Addendum

Florida Gateway College
New Building 102 – STEM Two
FGC ITB # ST-24-01-06
Lake City, Florida

02

May 14, 2024

LIGHTING PLAN - FIRST FLOOR
 SCALE: 3/16" = 1'-0"

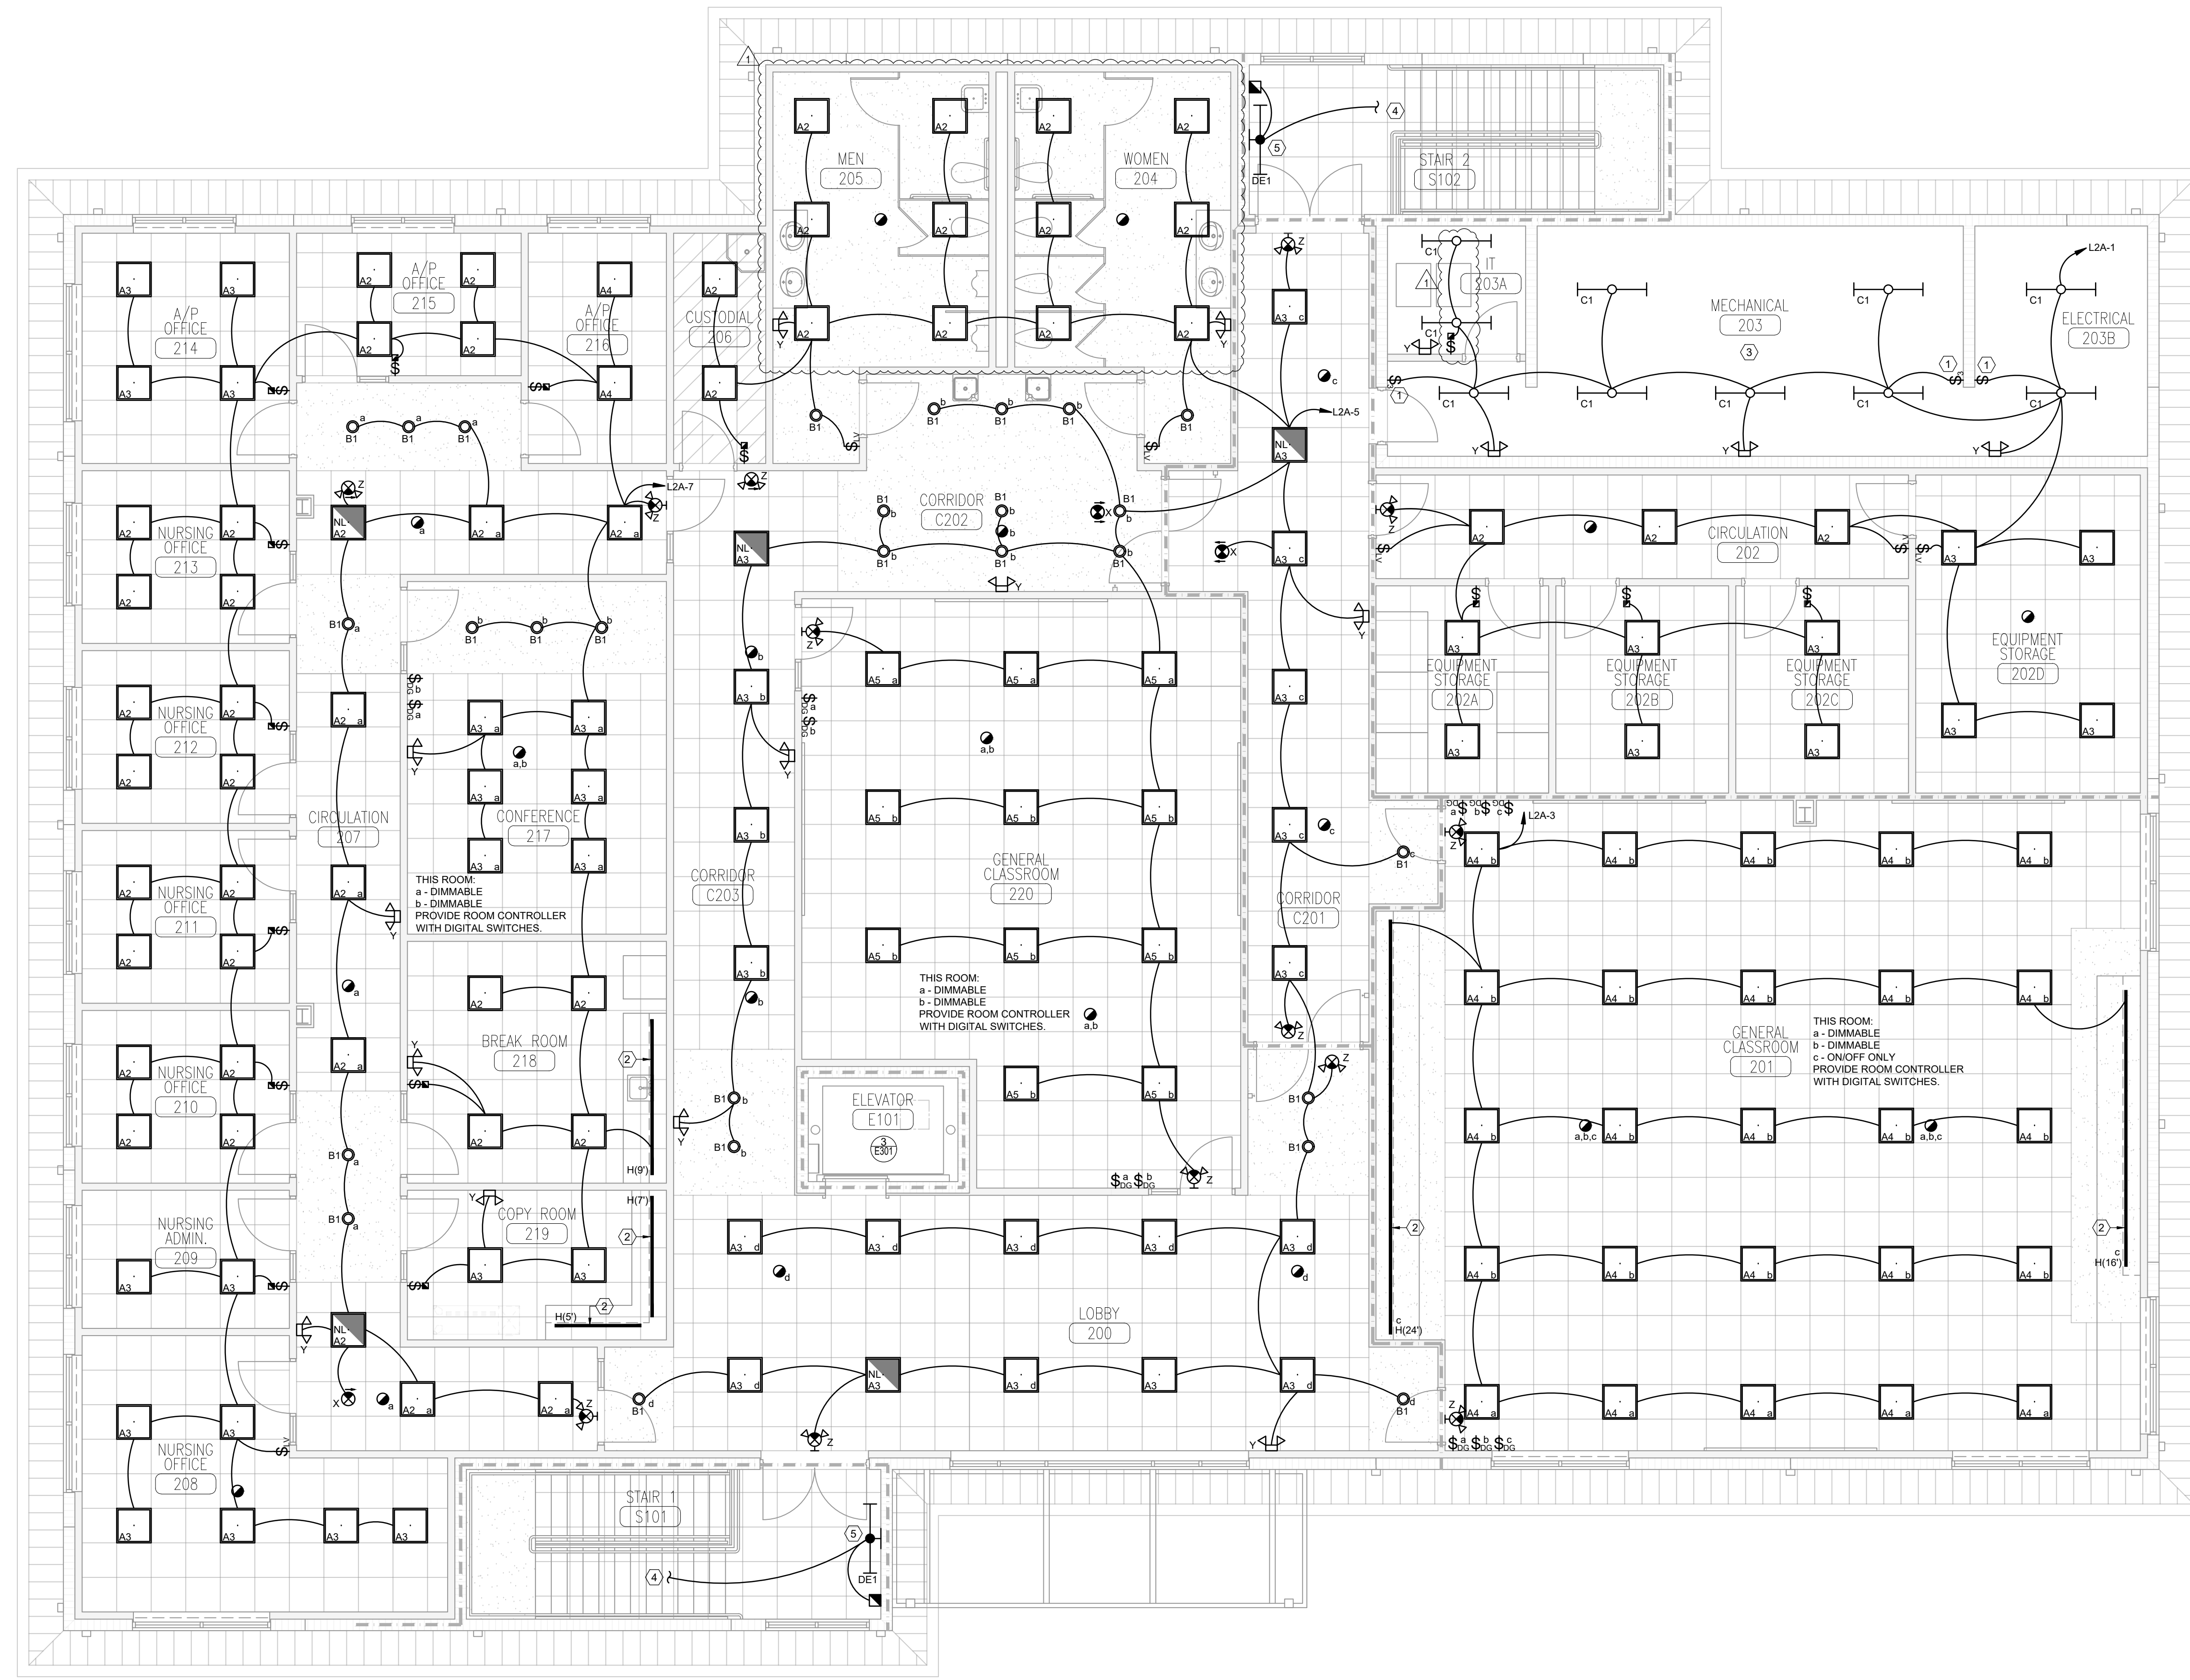
27. **DRAWINGS, SHEET E201 - LIGHTING PLAN - FIRST FLOOR, E202 - LIGHTING PLAN - SECOND FLOOR, E211 - POWER AND SYSTEMS PLAN - FIRST FLOOR AND E212 - POWER AND SYSTEMS PLAN - SECOND FLOOR:** Refer to the attached reissued Sheets. Added notes regarding location of boxes with respect to hard ceiling. Added some circuiting arcs which did not plot on original Drawings.

POWER & SYSTEMS PLAN - FIRST FLOOR
 SCALE: 3/16" = 1'-0"

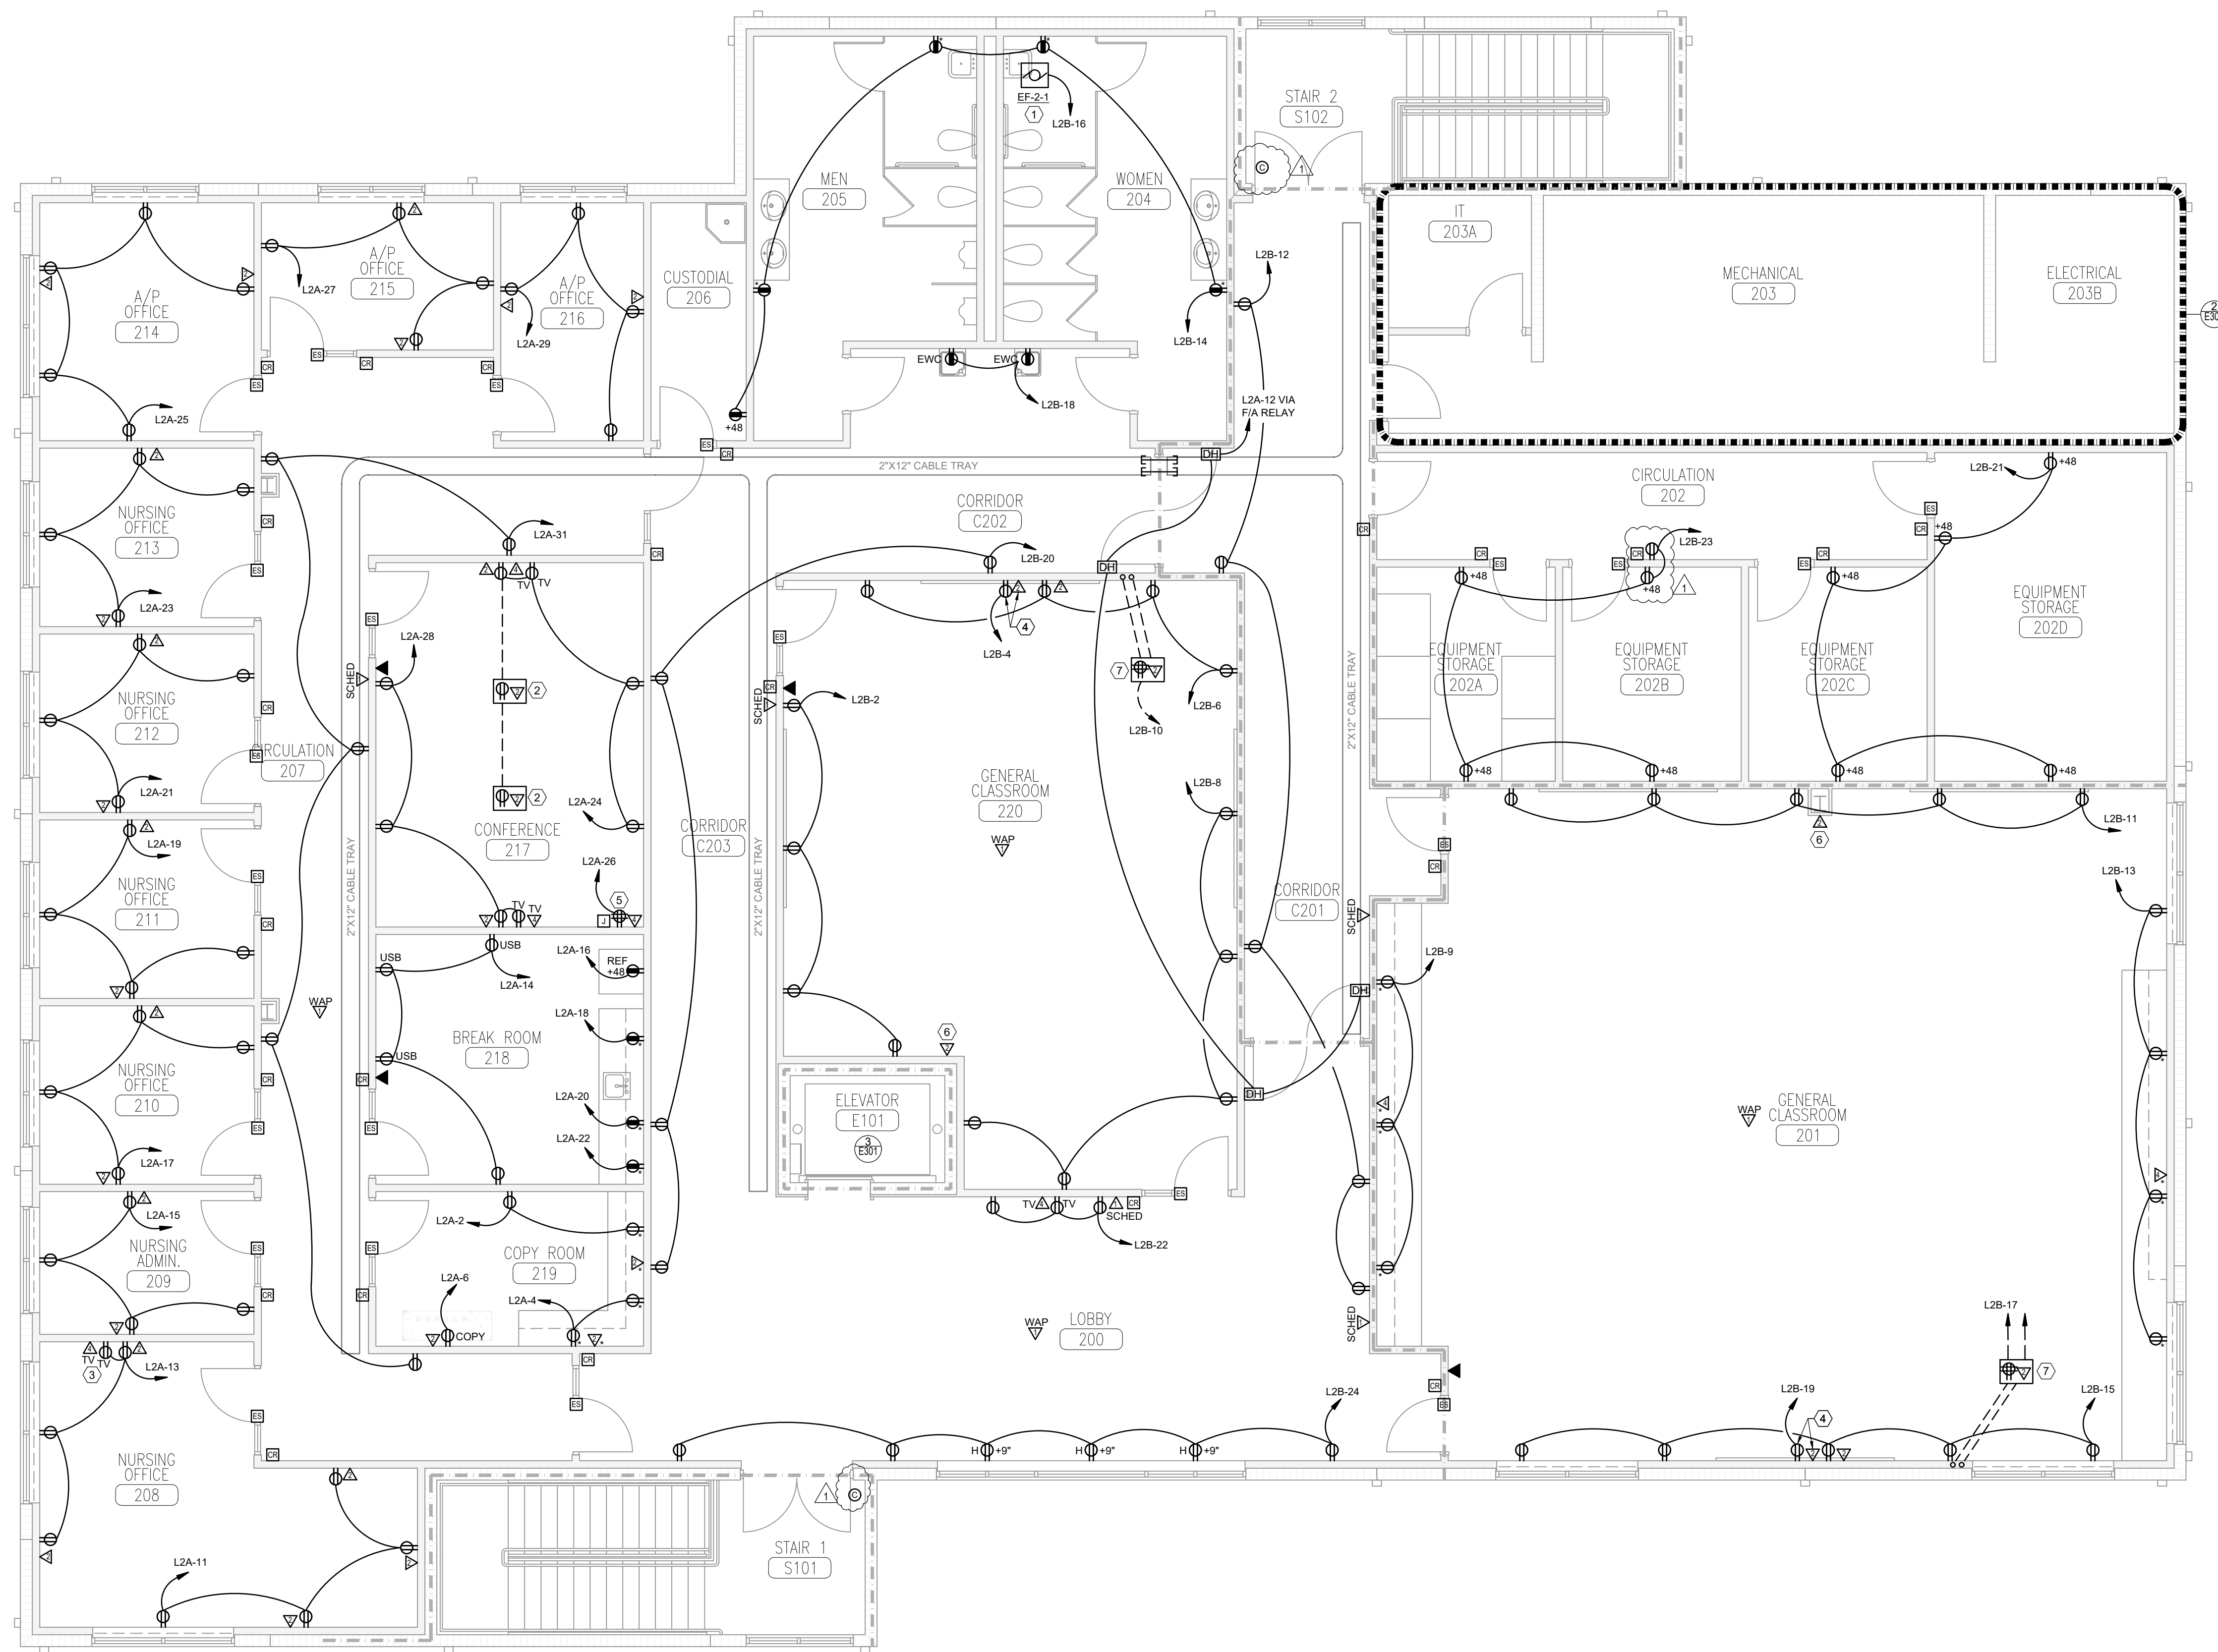
28. **DRAWINGS, SHEET E211 - POWER AND SYSTEMS PLAN - FIRST FLOOR:** Refer to the attached reissued Sheet. Electric strike from door to room #112 was added to plan.

29. **DRAWINGS, SHEET E211 - POWER AND SYSTEMS PLAN - FIRST FLOOR:** For clarification, a pre-bid RFI asked: "The simulation rooms on the first floor show cameras, but there is no specification or description of this system. Please advise on what is to be included?" and the response is: "See keynote 9 on E211, and notes T11 and T15 on E701. The contractor is responsible for the back boxes at each camera location and cables from the camera locations back to the I.T. room. The cameras will Owner-Furnished and Owner-Installed.

30. **DRAWINGS, SHEET E211 - POWER AND SYSTEMS PLAN - FIRST FLOOR AND E212 – POWER AND SYSTEMS PLAN – SECOND FLOOR:** Refer to the attached reissued Sheets. Security camera locations were added to plans. Contractor shall provide rough-in and CAT6 POE (power over Ethernet) cable for each location; camera will be provided by the Owner's security vendor.
